Figure: **4-22**

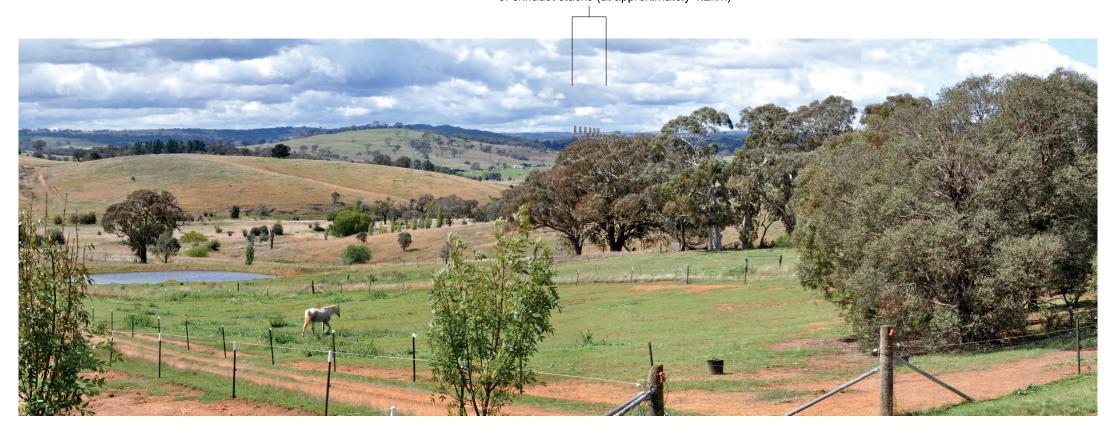
Visual: This submission expresses a high level of concern related to the visual impacts of the proposal. The submission notes that the view from all living areas of the home will encompass the power plant stacks.

A photomontage has been prepared from the left hand portion of the residential dwelling veranda looking toward the proposed Power Station and is presented as **Figure 4-22**. The photomontage has been produced using a maximum design height of 46m for the exhaust stack structures; however, the final constructed height of the exhaust stacks may be significantly lower which will reduce the overall level of visibility and resultant visual impact. The photomontage is therefore conservative in nature.
